**SUSQUEHANNA STEAM ELECTRIC STATION
REQUEST FOR ADDITIONAL INFORMATION
REGARDING PROPOSED AMENDMENT NO. 238
TO LICENSE NPF-14: MCPR SAFETY LIMITS
PLA- 5406**

Attachment 1 to PLA-5406

Figure 1
MCPH Safety Limit Methodology

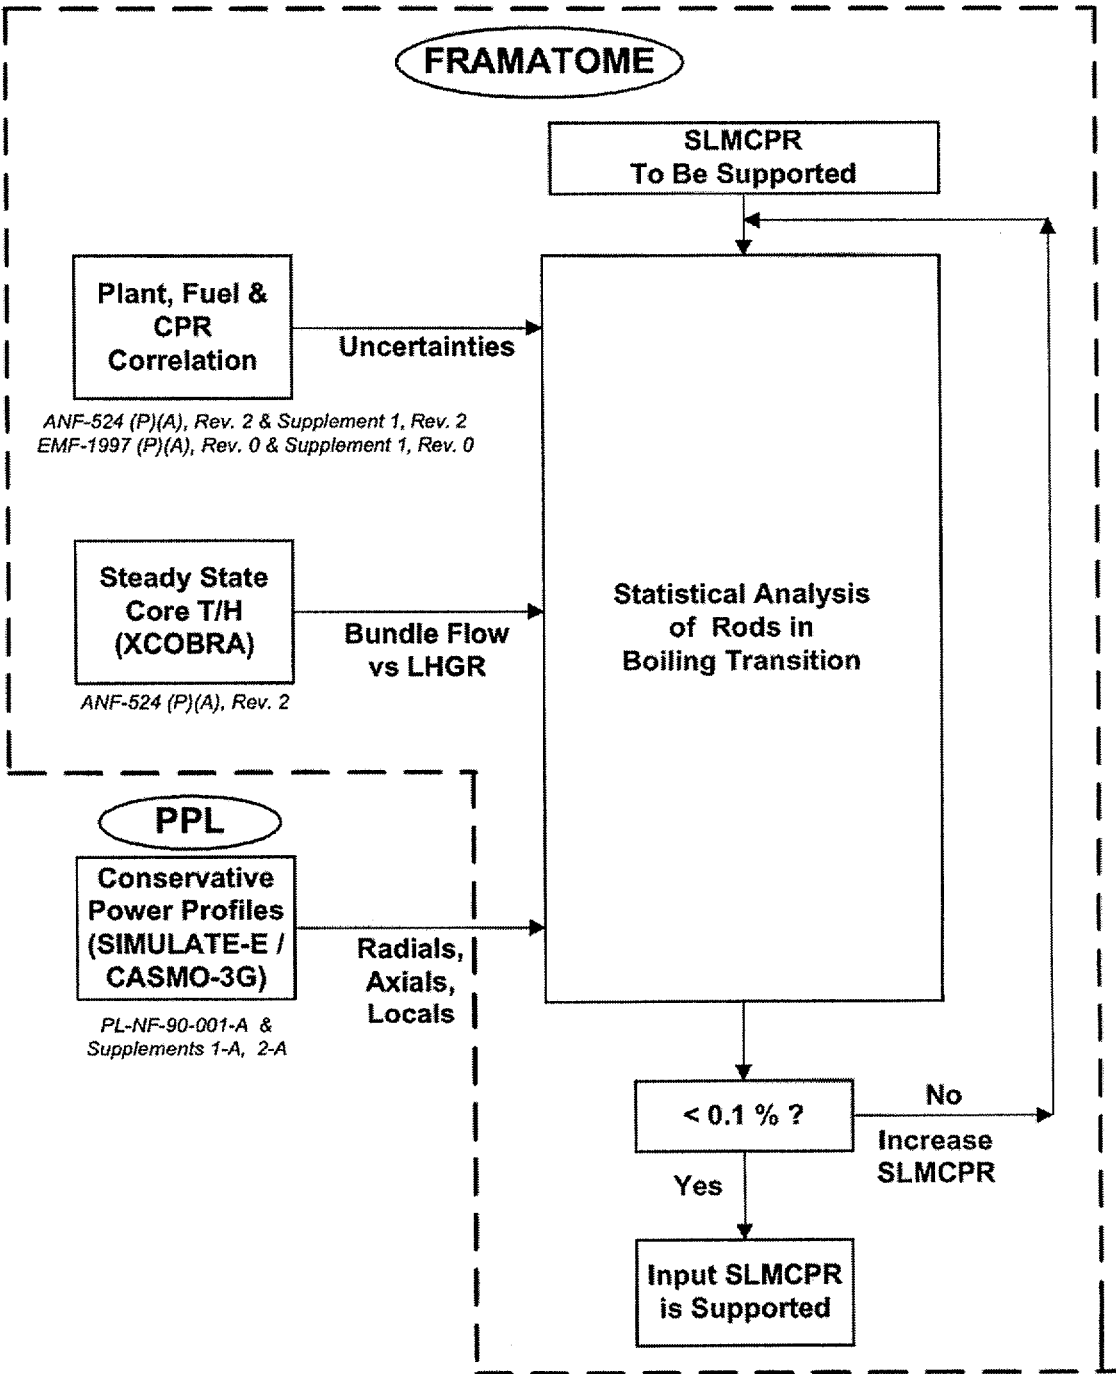
NRC requested a flow chart be provided to: (1) show which TS 5.6.5.b analysis methods are used to calculate the MCPR Safety Limit, (2) identify the calculation flow and (3) indicate which analyses are performed by PPL and which are performed by Framatome - ANP.

Susquehanna Unit 1 Technical Specification Section 5.6.5.b lists a number of approved methodologies that are applied to analyze the behavior of SSES during Cycle 13. Several of these methodologies are applicable to the calculation of the MCPR Safety Limit. Figure 1 provides a flowchart which illustrates the NRC approved methods listed in Technical Specification Section 5.6.5.b, which apply to the separate portions of the Safety Limit analysis and the organization that performs the analysis (PPL Susquehanna, LLC or Framatome - ANP).
